April 6, 2020

Subject: Bangor Savings Bank Windham Branch/Office Building
745 & 747 Roosevelt Trail, Windham, Maine
Response to Staff Review Comments

SITE PLAN Scale 1" = 80 ft.

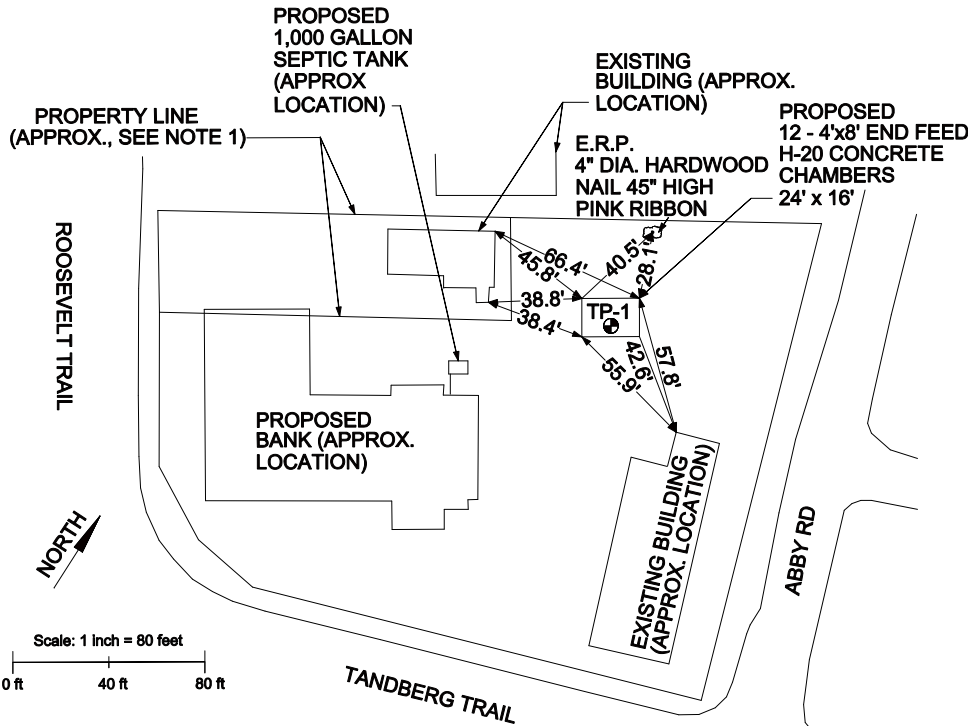
- 1. Evidence meeting the requirements of 811.1.(d)(2)(ii): "The location and dimensions of all provisions for water supply and wastewater disposal, and evidence of their adequacy for the proposed use, including soils test pit data if on-site sewage disposal is proposed." (We usually accept an HHE-200)**

SME Response: SME submitted an electronic copy of a completed HHE-200 form to the Planning Office via email on April 1, 2020. A copy of the completed HHE-200 form is attached to this letter for reference.

SITE PLAN - PYLON LOCATIONS
NO SCALE

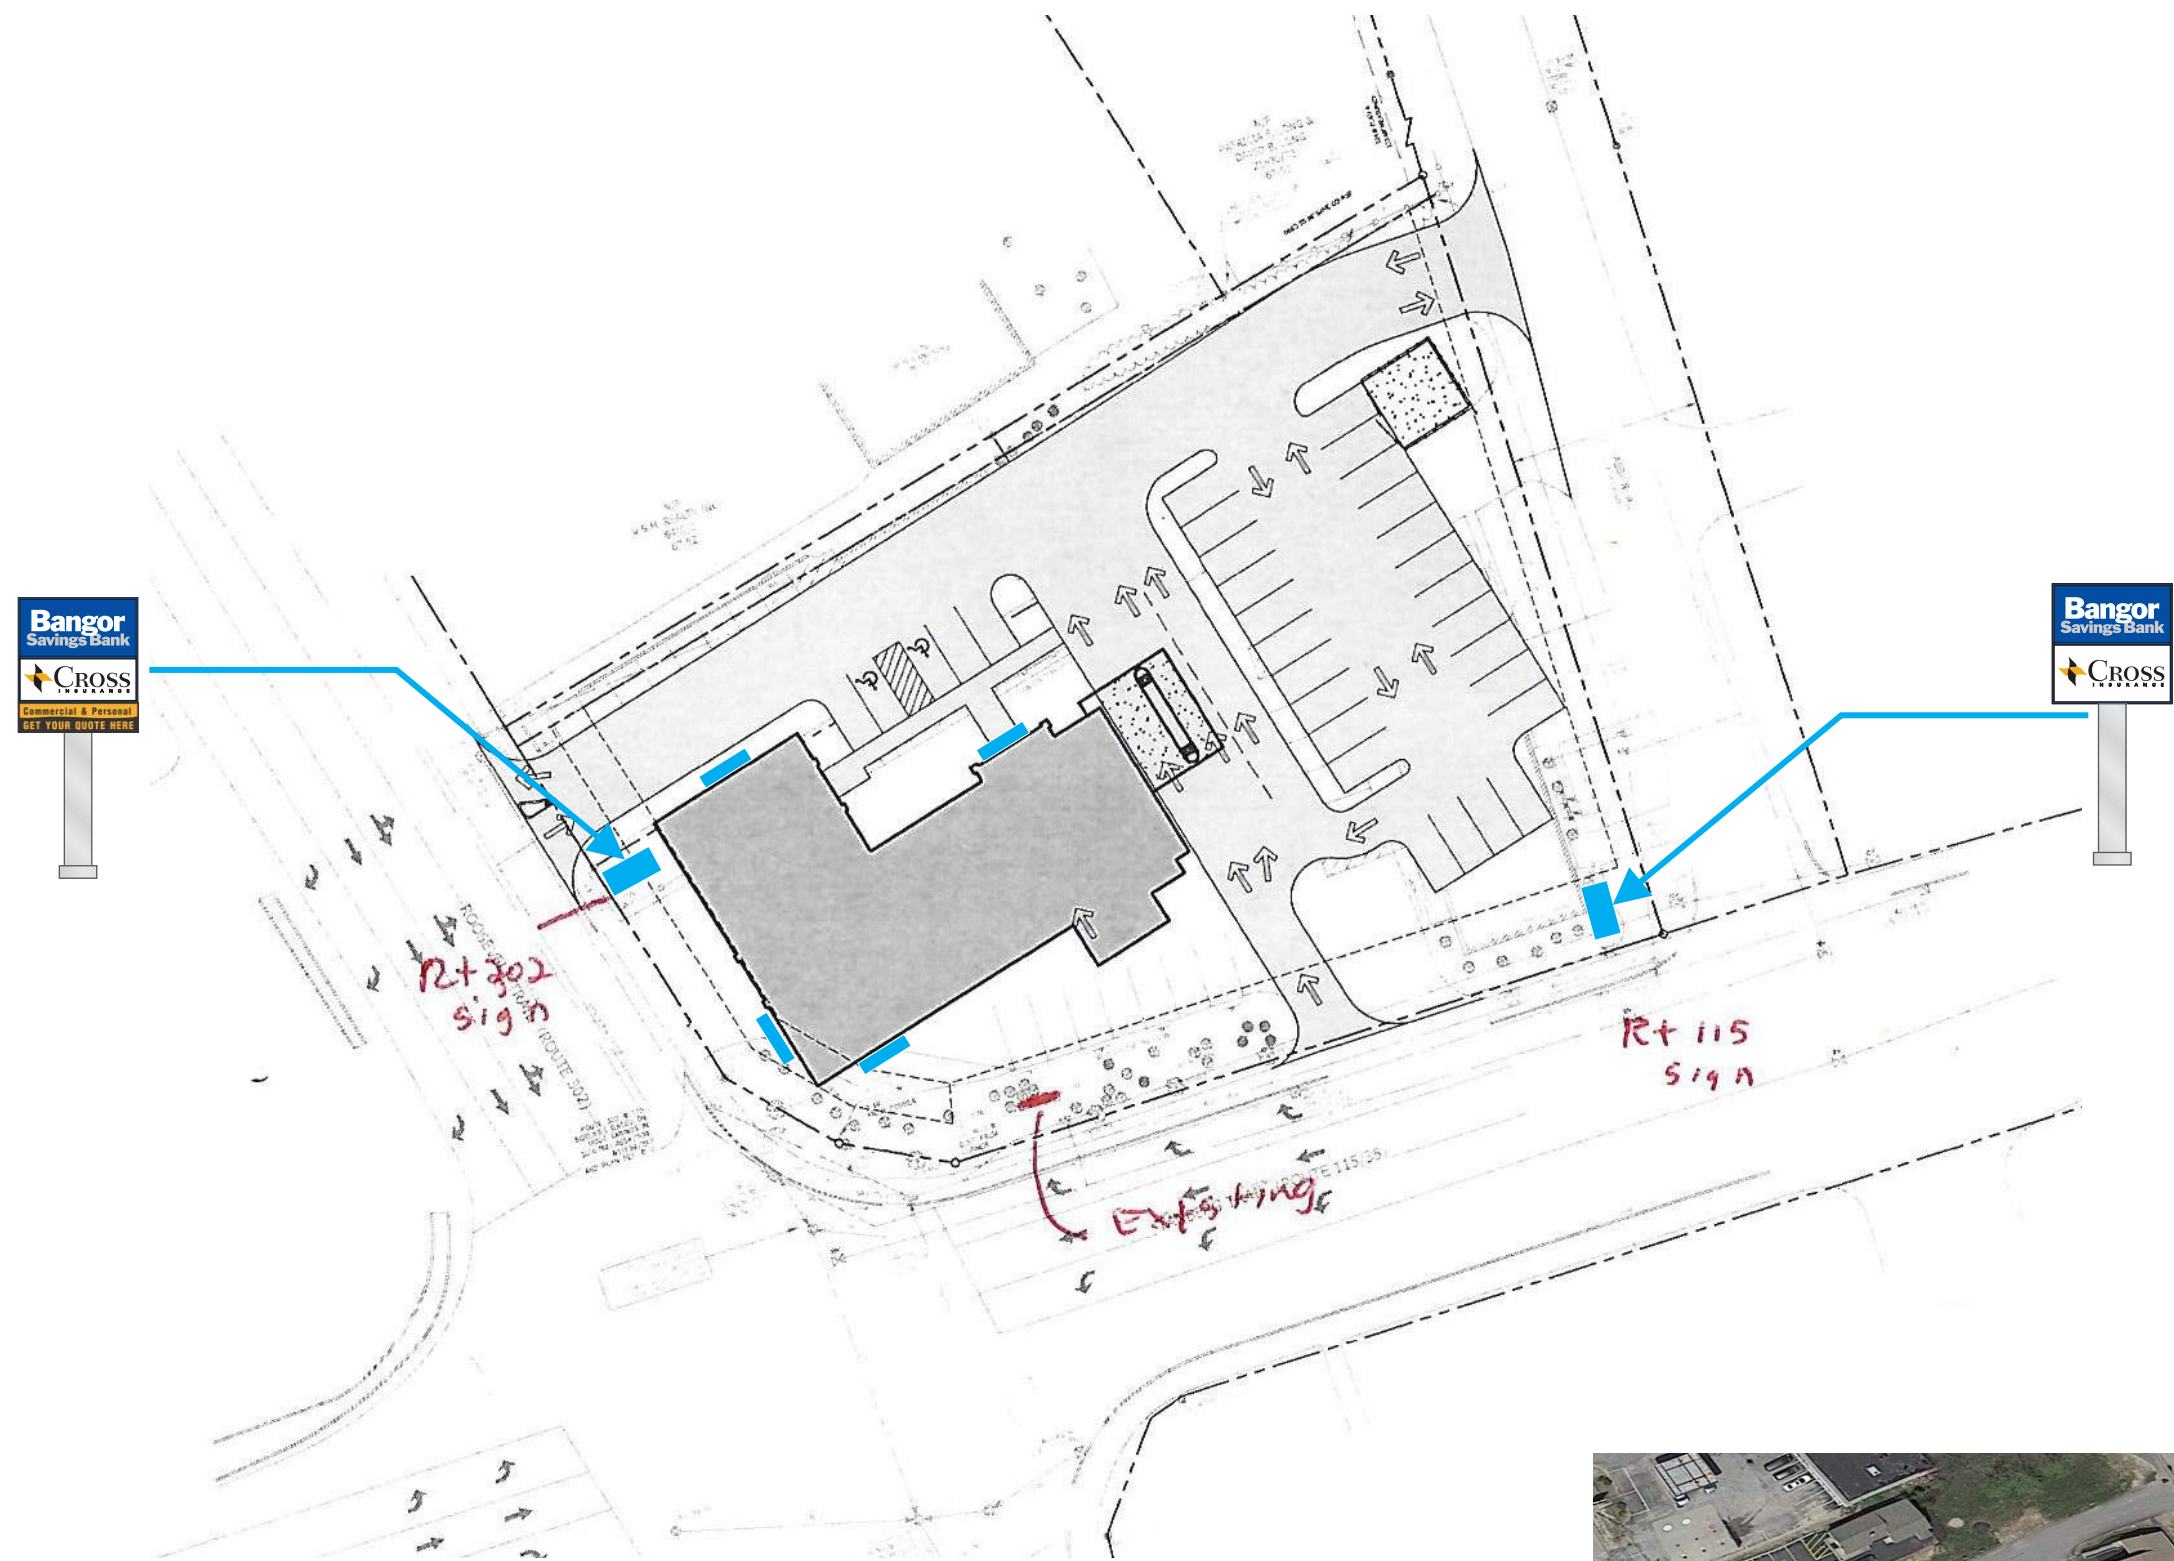
4. **Location, front view, materials and dimensions of proposed signs with method for securing signs. (Also show existing signs, and indicate if they will stay, or indicate otherwise)**

SME Response: Building mounted signs are outlined on the architectural elevations included in the Application package as Attachment H. Design sheets from Neokraft Signs, Bangor Savings Bank's sign consultant, are attached to outline the location, front view, and dimensions for proposed free-standing signs for this project. All existing signs on the property will be removed before project completion.

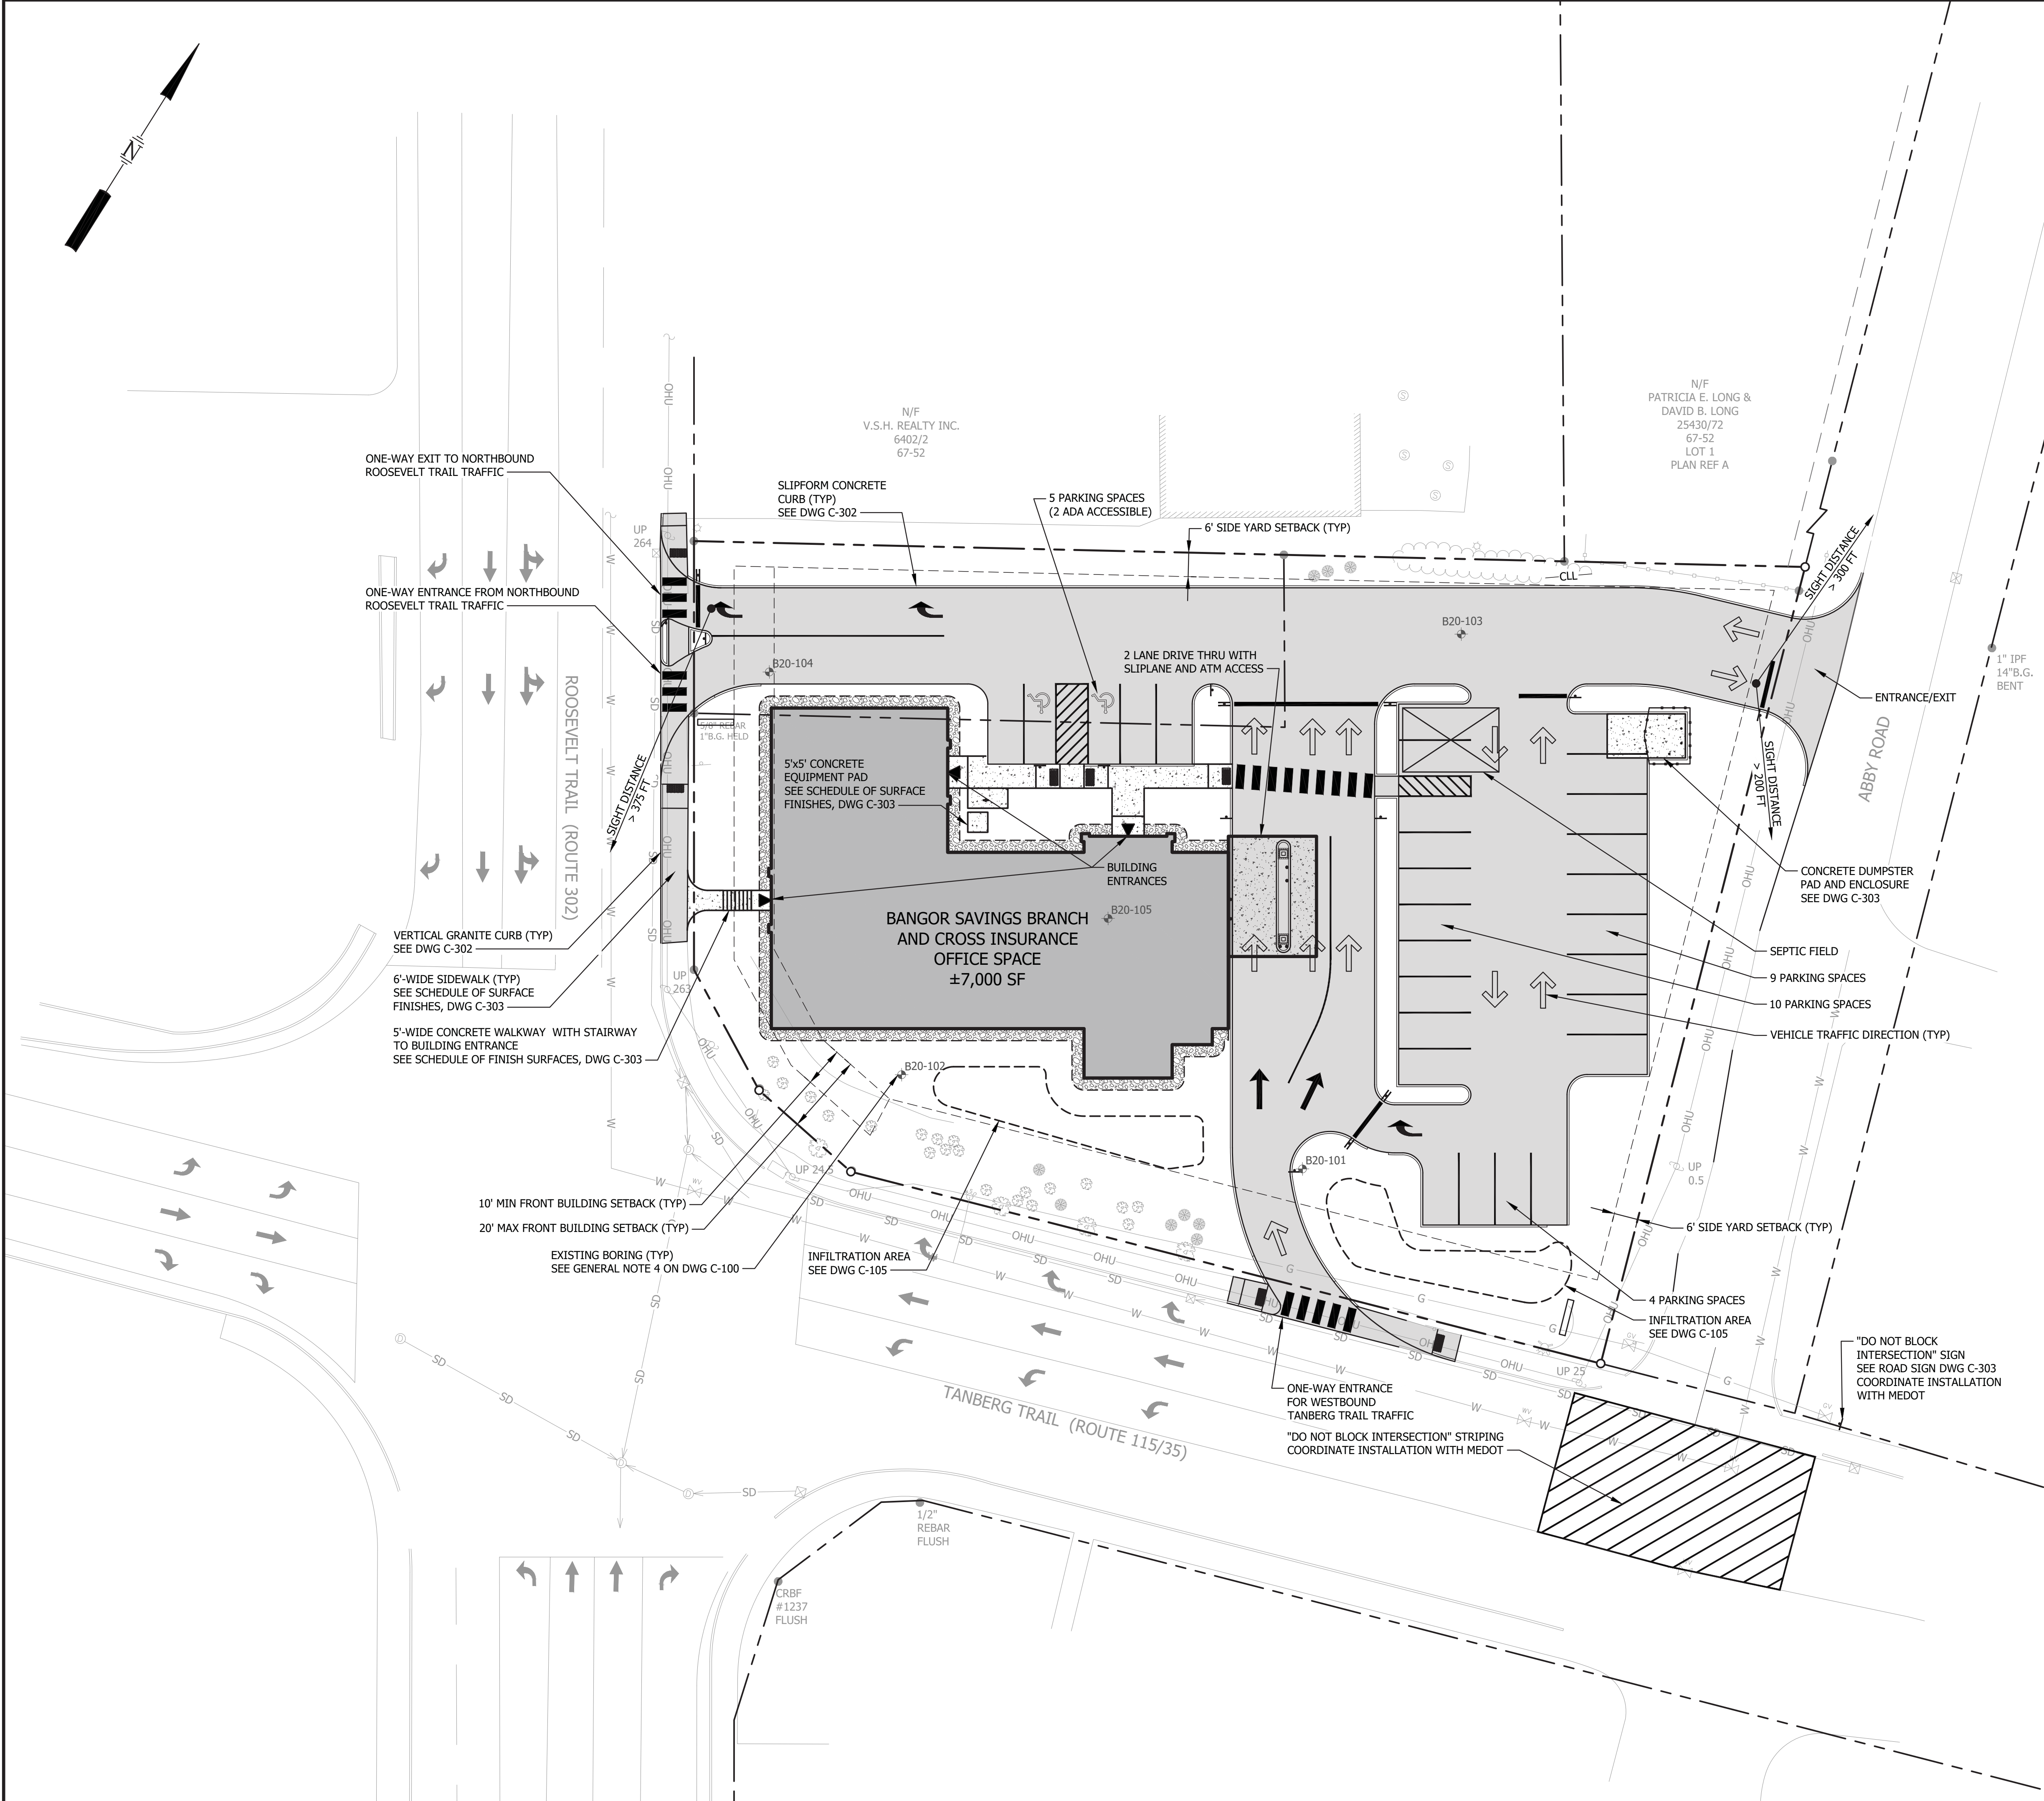
1. **For infiltration Basin 2 (Pond 1CP1) the peak elevation for the water level in the basin calculated by HydroCad is 309.35' for the 25-yr storm compared to the top of the basin at 309.50'. Overflow, if/when it occurs, will likely flow onto the entrance to the drive-through on Route 115. The 0.15' of freeboard does not seem to be sufficient considering the overflow would go onto Rte. 115. It is recommended that the basin design be modified to provide at least 1 foot of freeboard.**

SME Response: Infiltration basin 2 (Pond 1CP1) is designed to provide 0.5 feet of freeboard above the emergency spillway elevation. Spot grades have been added to the grading plan for

clarity. Overflow is intended to travel overland to the municipal storm drain system in the right-of-way based on initial design recommendations from Town staff. Copies of the updated plan sheets, an updated stormwater quantity analysis, and updated post-development stormwater modeling calculations are attached for reference.
